City of West Allis

Plan Commission

Wednesday, July 22, 2026

STAFF REPORT
WEST ALLIS PLAN COMMISSION
Wednesday, July 22, 2026
6:00 PM

Maps of the proposed changes to the Zoning Map and 2045 Comprehensive Plan can be found below:

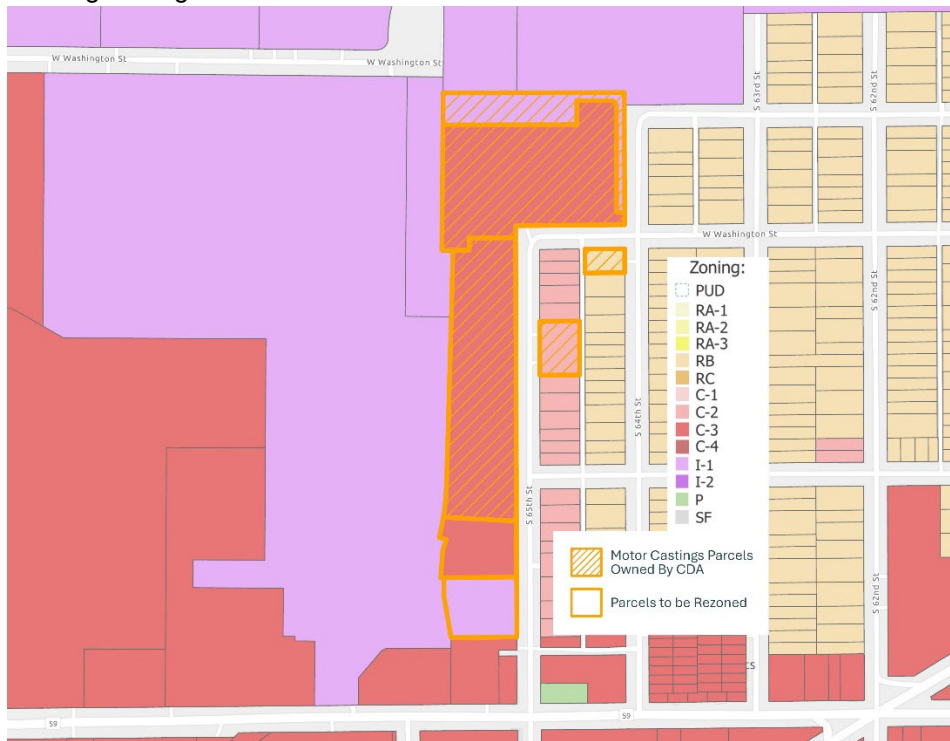
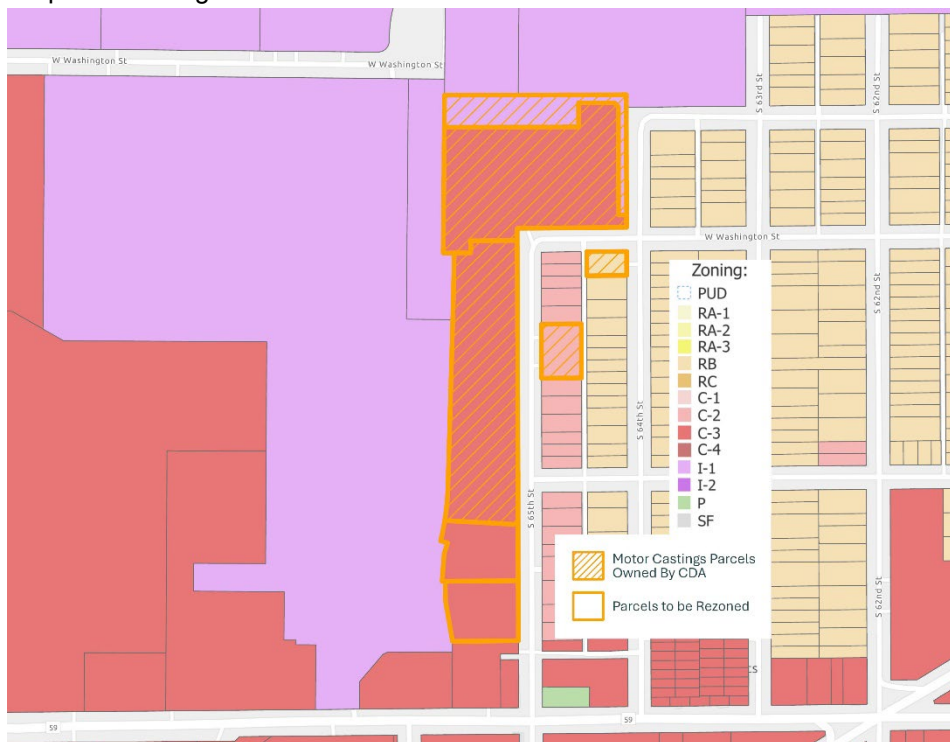
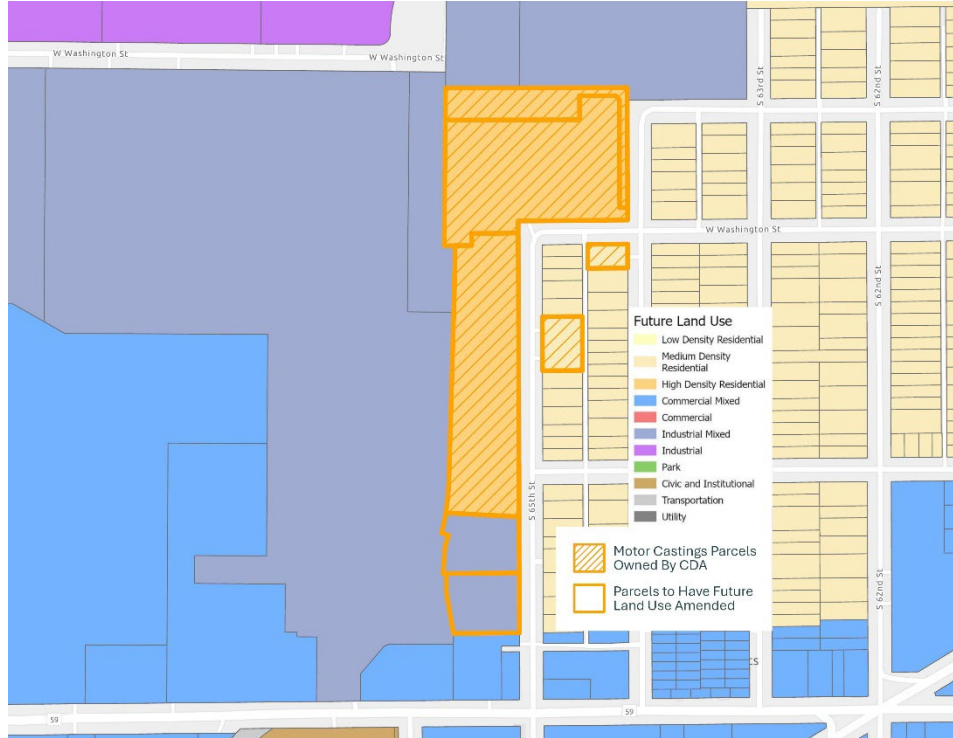
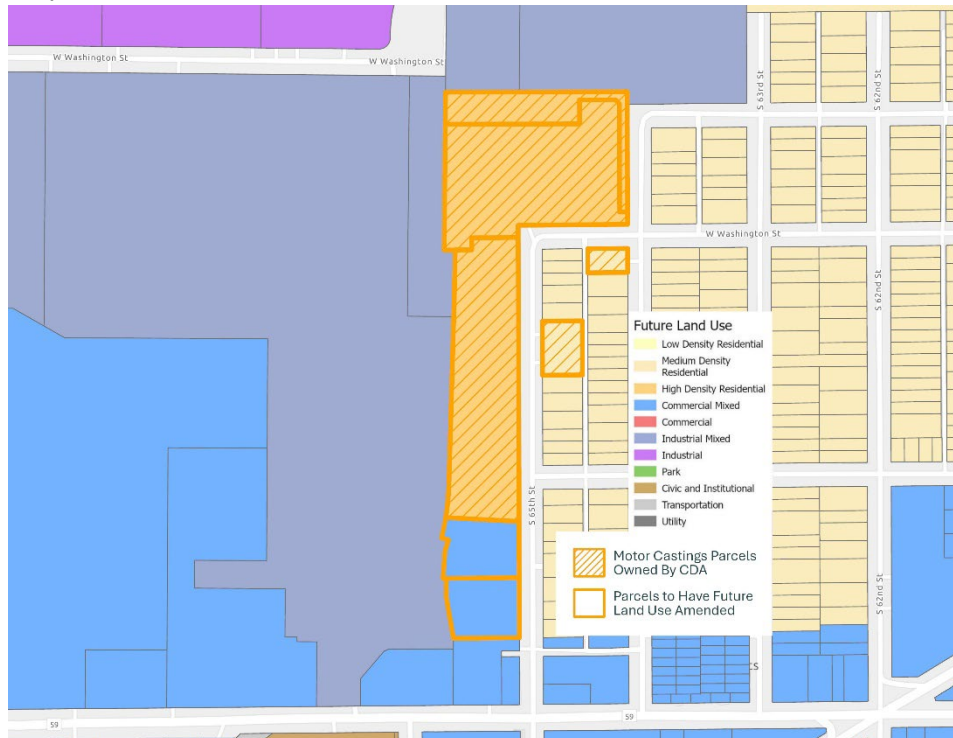
To proactively address any potential nuisances or incompatible land uses, staff recommends rezoning the property at **1339–47 S. 65th Street** from **industrial** to **commercial** and amending the future land use from **industrial** to **commercial mixed**. Staff recommends the property at 1323 S. 65th St. to retain the C-3 zoning, but, have the future land use amended from **industrial** to **commercial mixed**. This action would:

Recommendation: Common Council approval of the Ordinance to amend the Zoning Map and 2045 Comprehensive Plan Future Land Use Map for properties along S. 65th St.

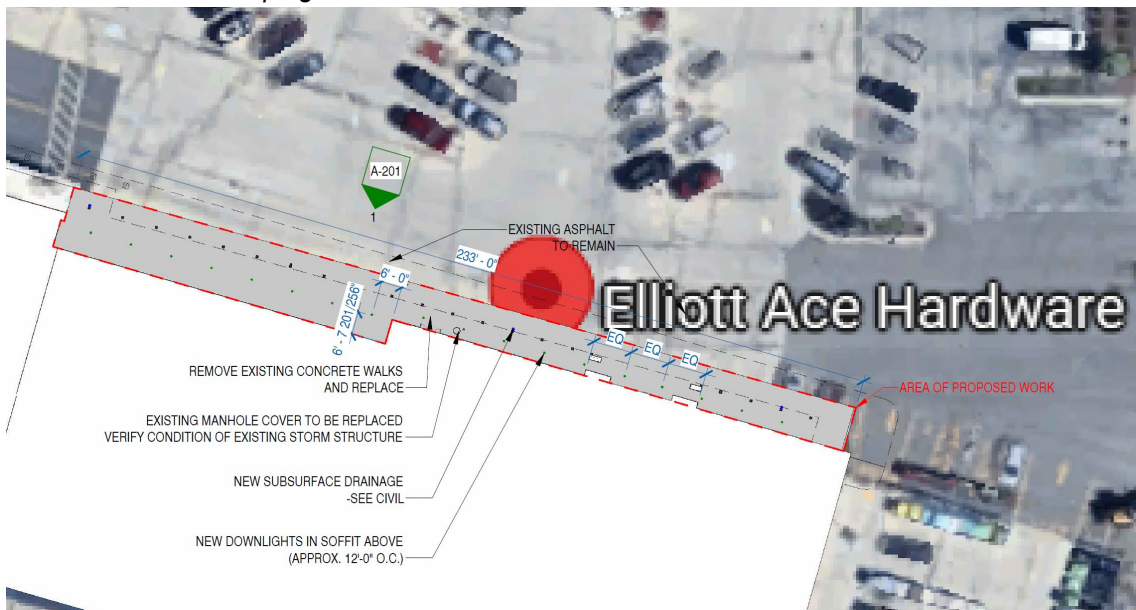
Refer to full set of plans toward the end of this report. Below shares a before and after rendered view of the exterior building improvements which will include replacement of the existing concrete walk directly in front of the store, repairing the existing brick veneer, painting the existing brick, and residing and metal roofing the front gable end. Exterior siding will be a darker color earthen tone hardi-siding. The plans note an alternate/option to complete entire storefront roof area with metal siding. Recessed downlighting being installed under storefront soffit.

1. Revised site and landscaping plan being submitted to the Planning and Zoning Department to show the following: (a) two new landscaping islands on south end caps of parking rows or a raised planter being added near the store entrance walkway as part of the new concrete sidewalk work that is planned; (c) clarification on roof materials over the balance of the existing asphalt shingles.
2. An electrical permit application to be applied for as part of lighting upgrades.
3. Contact Engineering Department for applicable permit if any work is planned within city right-of-way.

The Common Council required these islands at the public hearing.

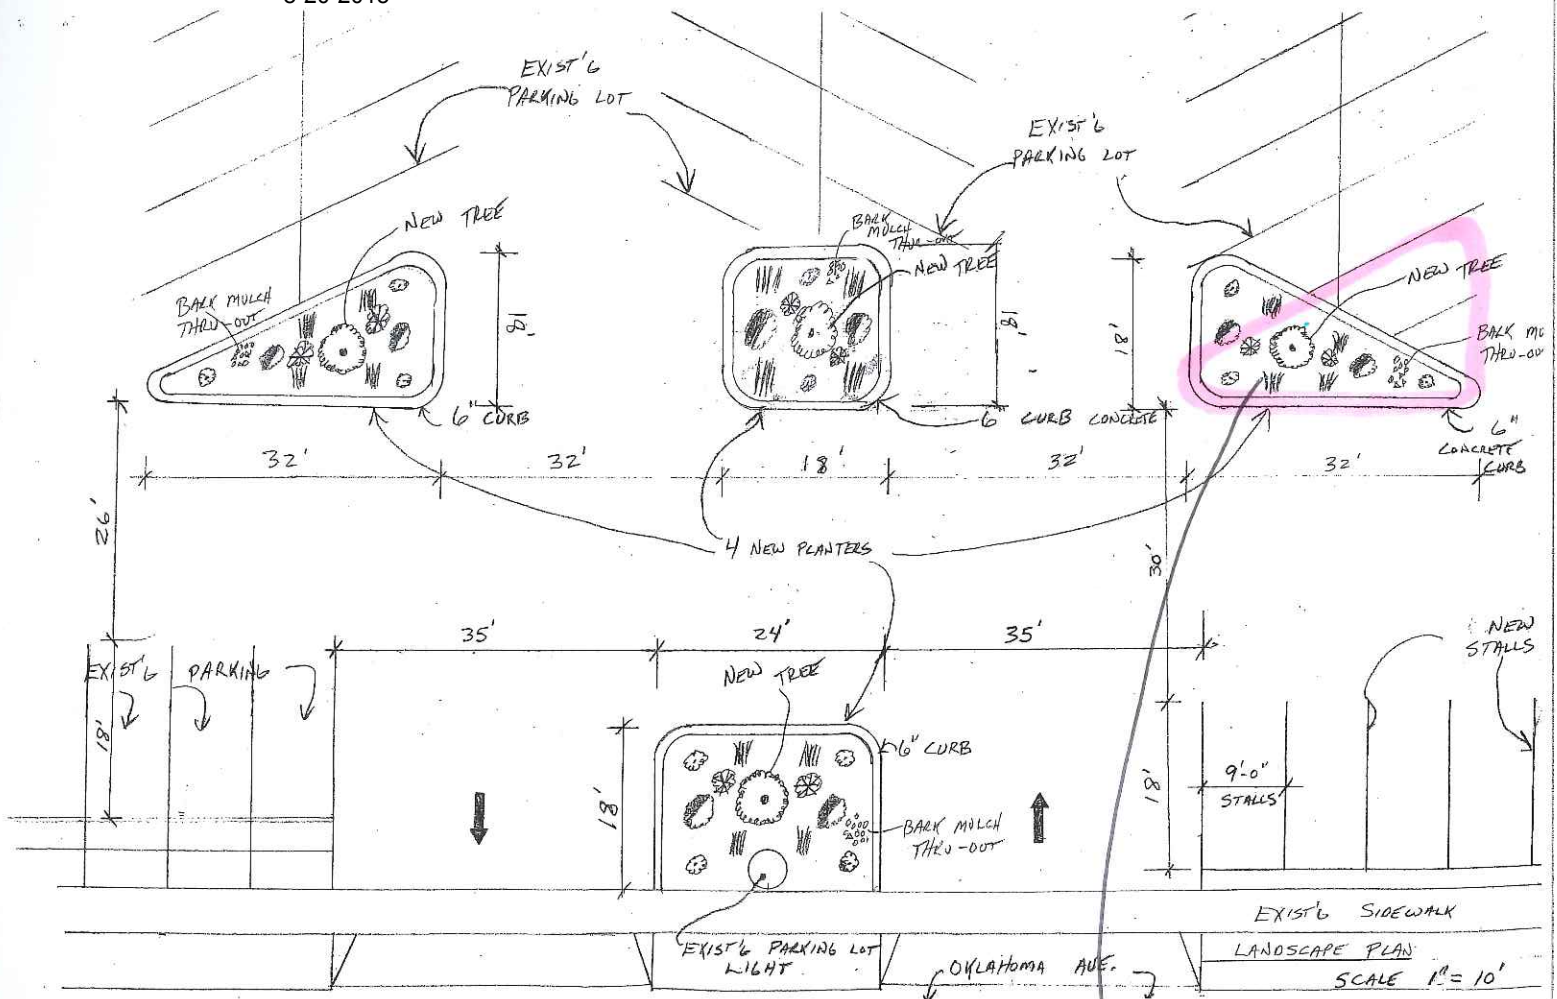
In 2015, as part of a special use hearing, the Common Council required ACE install landscaping islands near their driveway approach/entrance to the site from W. Oklahoma Ave. Staff is recommending ACE provide at least two new landscaping islands or a raised planter area along the store entrance as part of the new concrete work that is planned.

Sheet Title:
**SITE PLANS &
LANDSCAPING
PLAN**

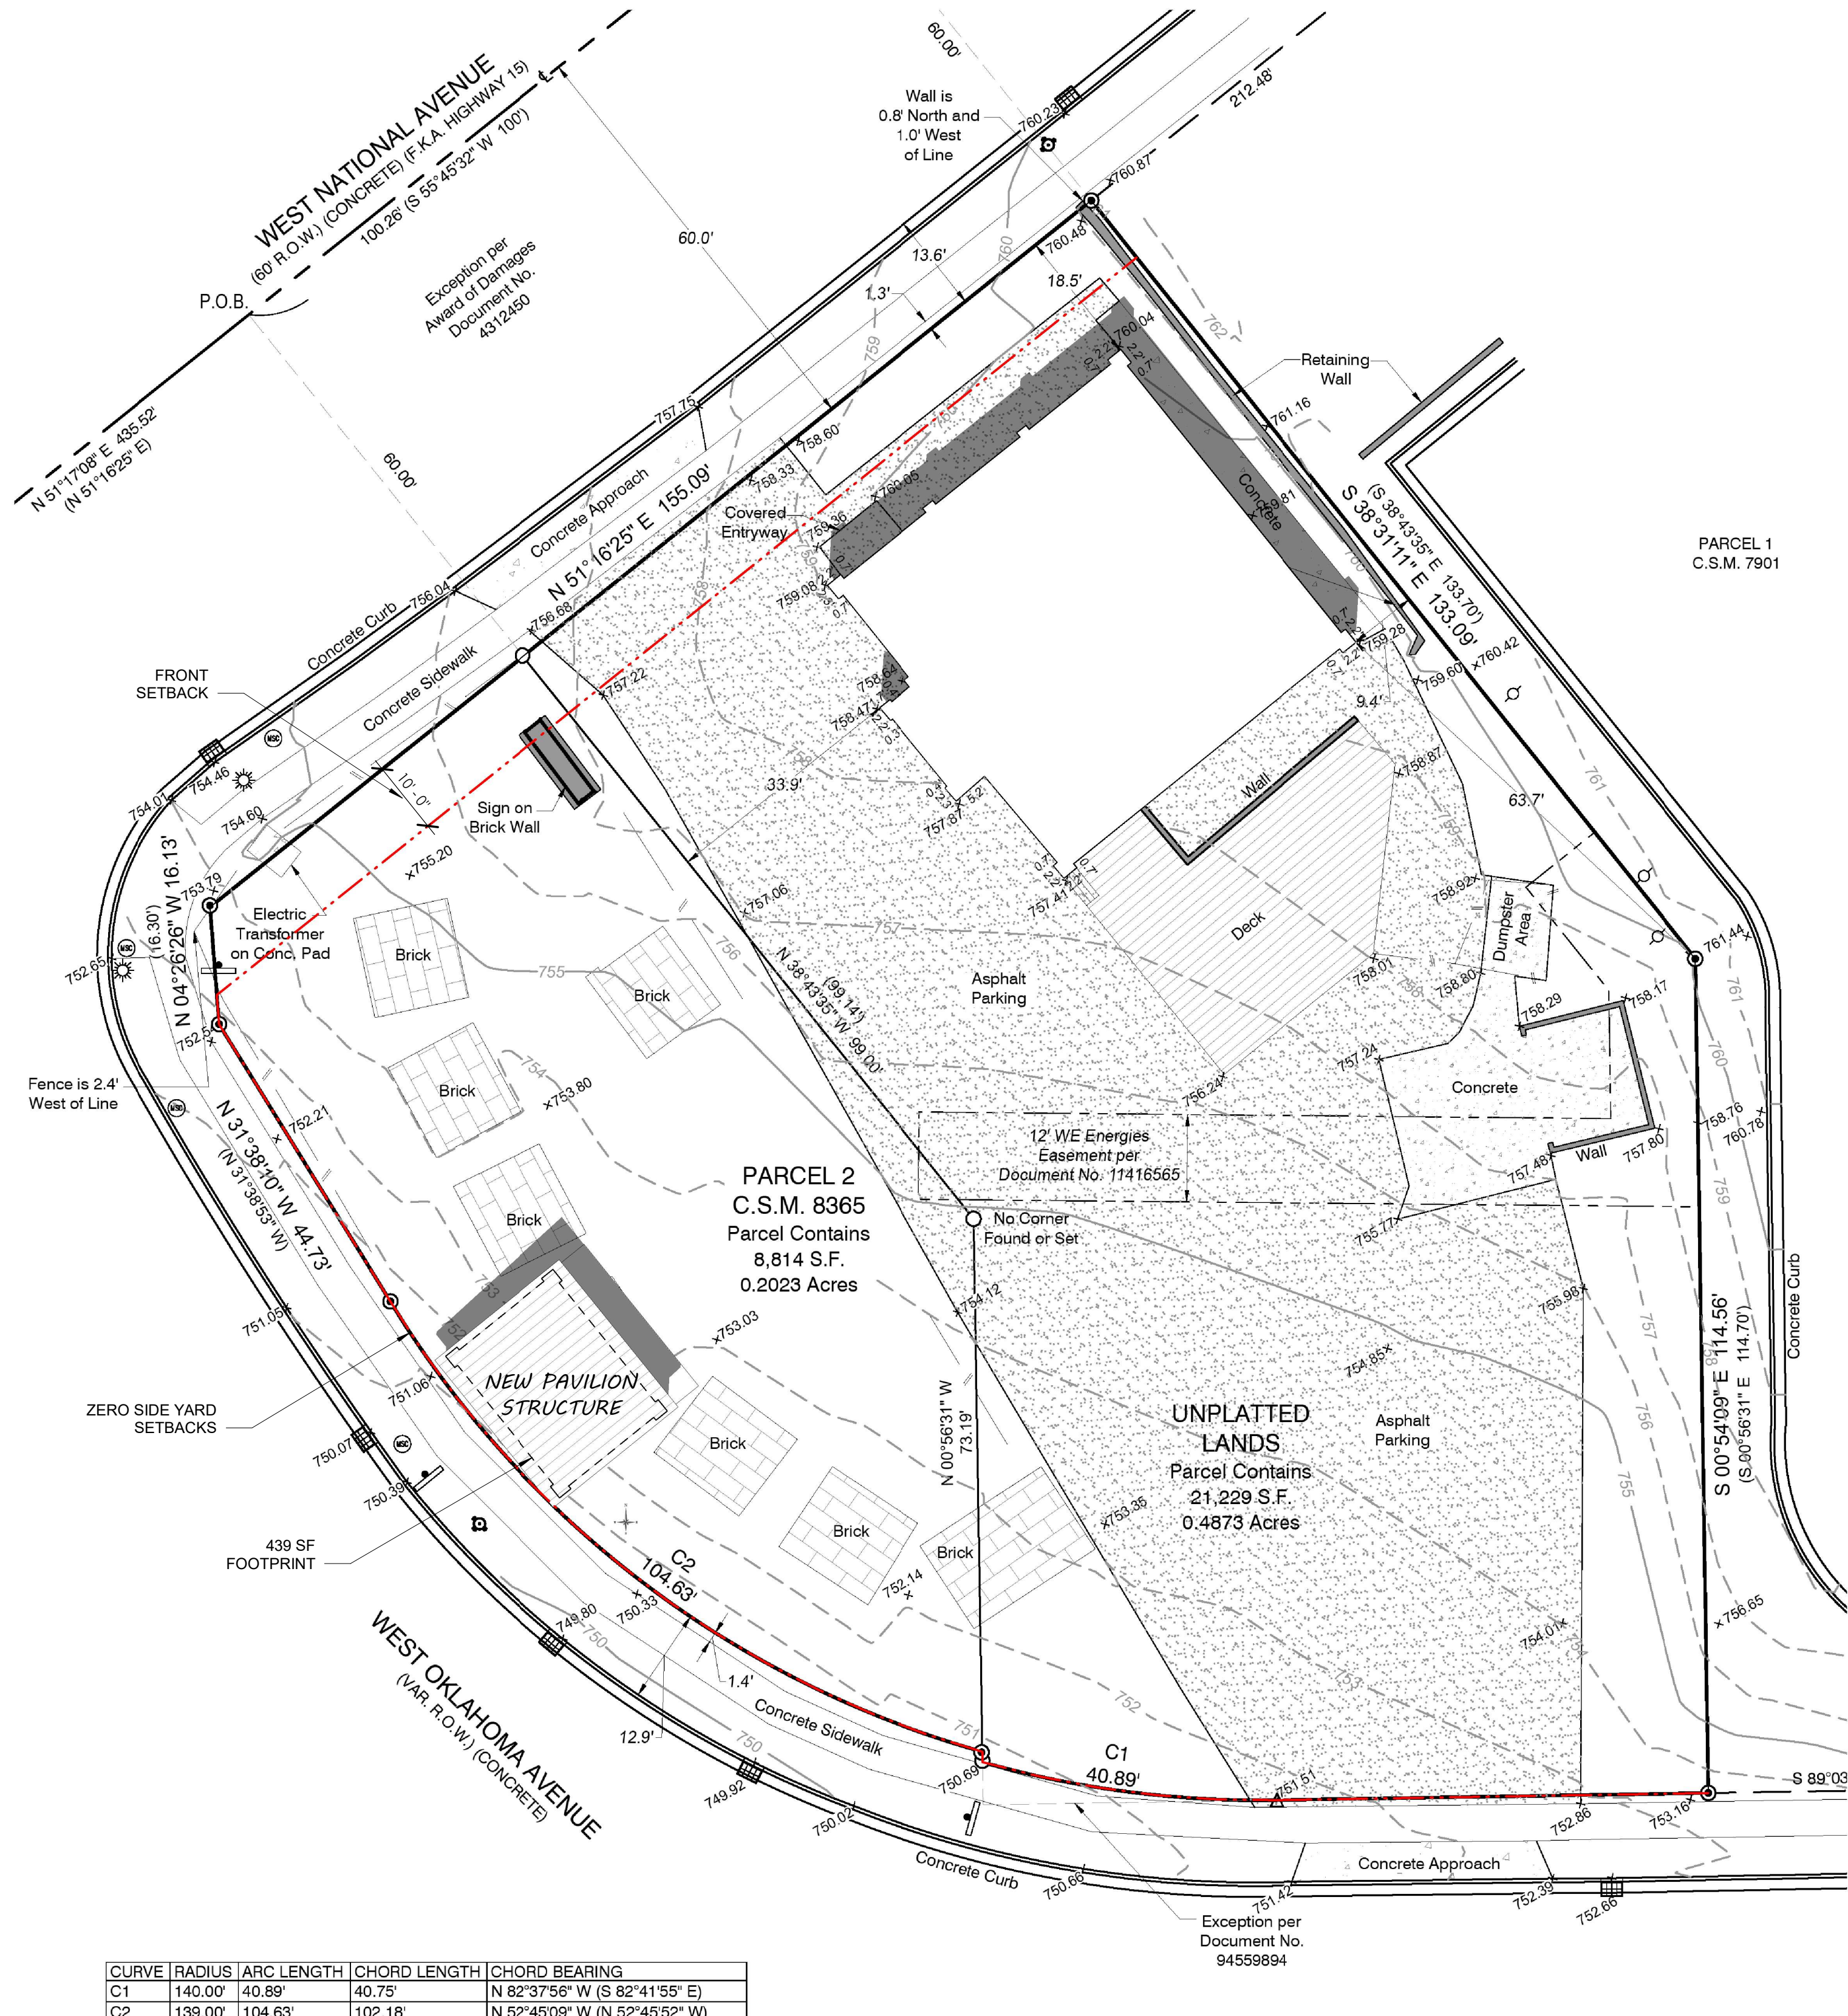
Landscaping will be added and modified on the western portion of the site. Approximately 12 evergreen trees, bushes, and shrubs will be relocated to the northwest region of the site, between the patios and sidewalk in line with existing landscaping. Salt tolerant plantings will be installed along the west pavilion elevation, not to exceed 2 ft in height to maintain signage visibility.

Planning staff has also considered the long-term vision for this site and encourage its use to the fullest potential. Due to the increased programming of Parcel 2 of the property, staff does recommend that the

1. Submission of a lighting plan for proposed lighting features submitted to the Planning and Zoning Department subject to review and approval.
2. Porta Potty locations and consideration of screen enclosure or landscaping being provided.
3. Combination of the two parcels into one lot of record.
